## PJM Manual 14D:

Generator Operational Requirements

~~Revision: 59~~ Revision: 60

Effective Date: ~~September~~ October 1, 2022

Exhibit XXX. An example of real-time data and account metering requirements for a Mixed Technology Facility, including measurement points. This facility is 75 MW or larger and

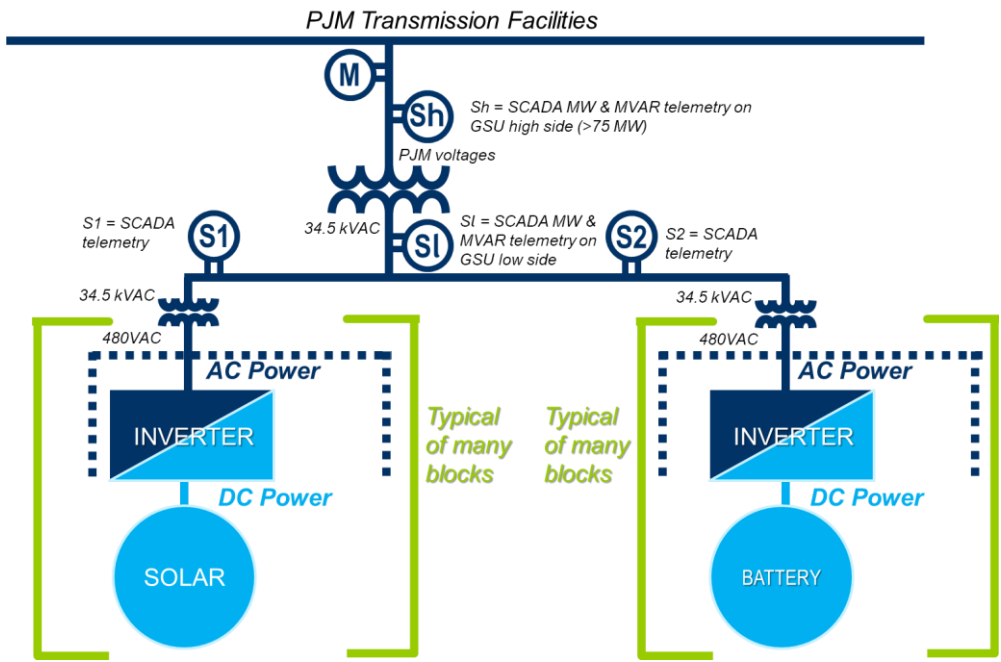
A Mixed Technology Facility shall have metering that measures non-real-time or revenue information corresponding to the Point of Interconnection (shown as "M" in Exhibit XXXX below). This metering shall meet the accuracy requirements for primary billing metering systems specified in Manual 01 section 5.3.2 (or other section of that manual as may be applicable). A Mixed Technology Facility participating in markets as multiple Co-Located Resources requires non-real-time MWh revenue information for each Co-Located Resource. Such MWh quantities may be calculated by apportioning the MWh measured for the entire Mixed Technology Facility across the Co-Located Resources. Such apportionment may be achieved pro rata based on the real-time MW telemetry for each Co-Located Resource.

Exhibit XXXXX below illustrates an example of a Mixed Technology Facility with a solar resource and an Energy Storage Resource, each participating separately in markets as a Co-Located Resource. In this example, all of the energy measured for the Mixed Technology Facility at "M" across an interval (e.g., 5 minutes) is split between the solar resource and the Energy Storage Resource pro rata according to the power measured at S1 (which measures all of the solar production) and at S2 (which measures all of the storage power flows) integrated over the interval.

Exhibit 11: Generation Deactivation Process Flow

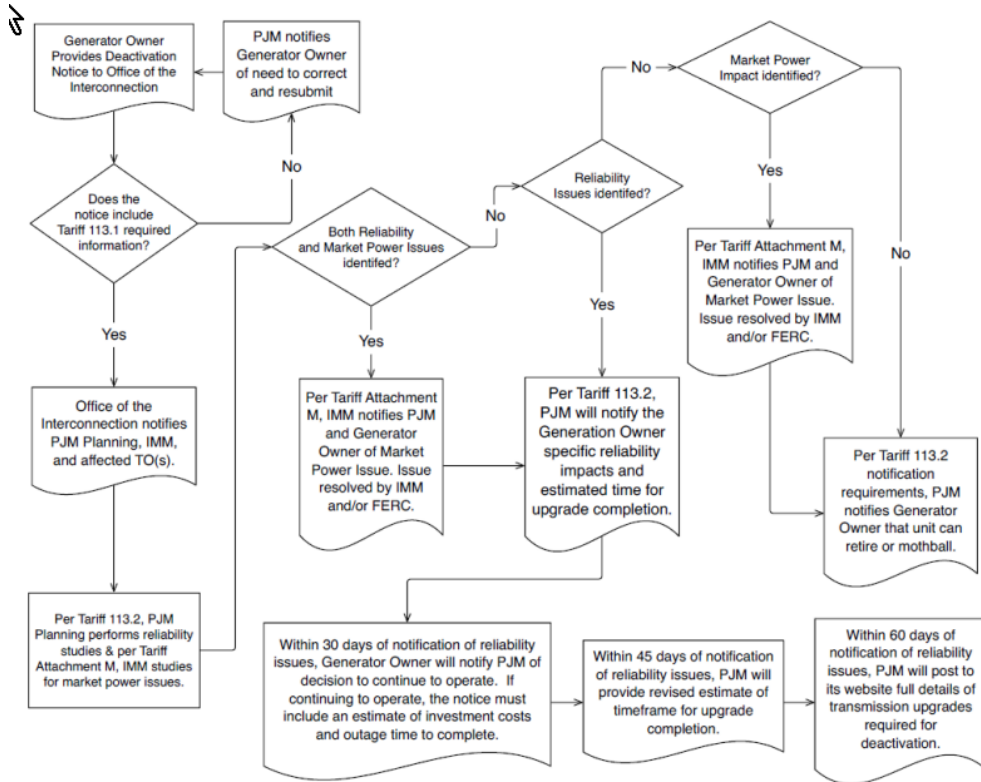
~~The following exhibit displays the generation deactivation process flow:~~

Exhibit 15: Example of inverter-based AC-coupled open-loop Hybrid Resource with 100 MW solar and 40 MW battery.

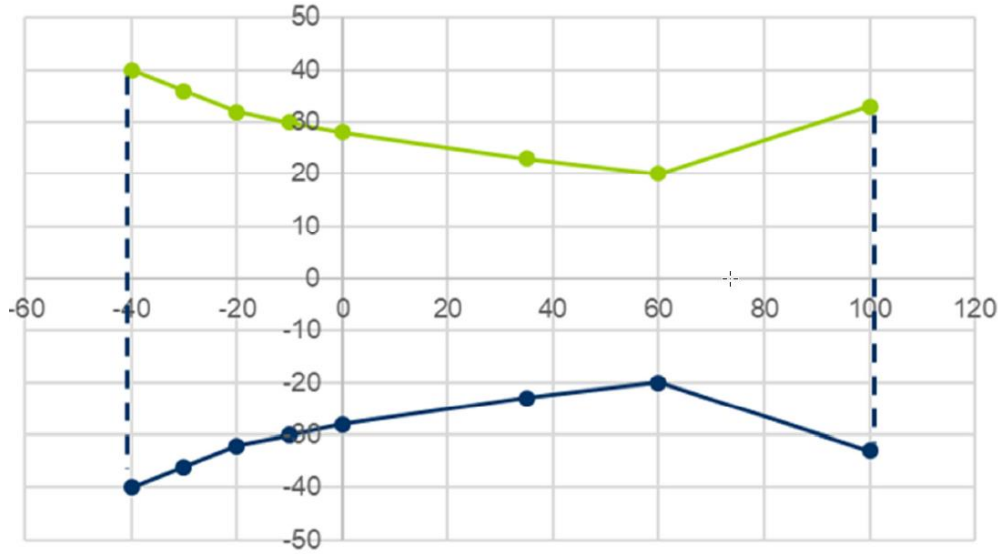
- 9.12. For a Hybrid Resource, the composite reactive capability curve shall represent the most conservative capability of the combined Generating Facility at each net MW injection point. See examples in Exhibits 15 & 16 below.
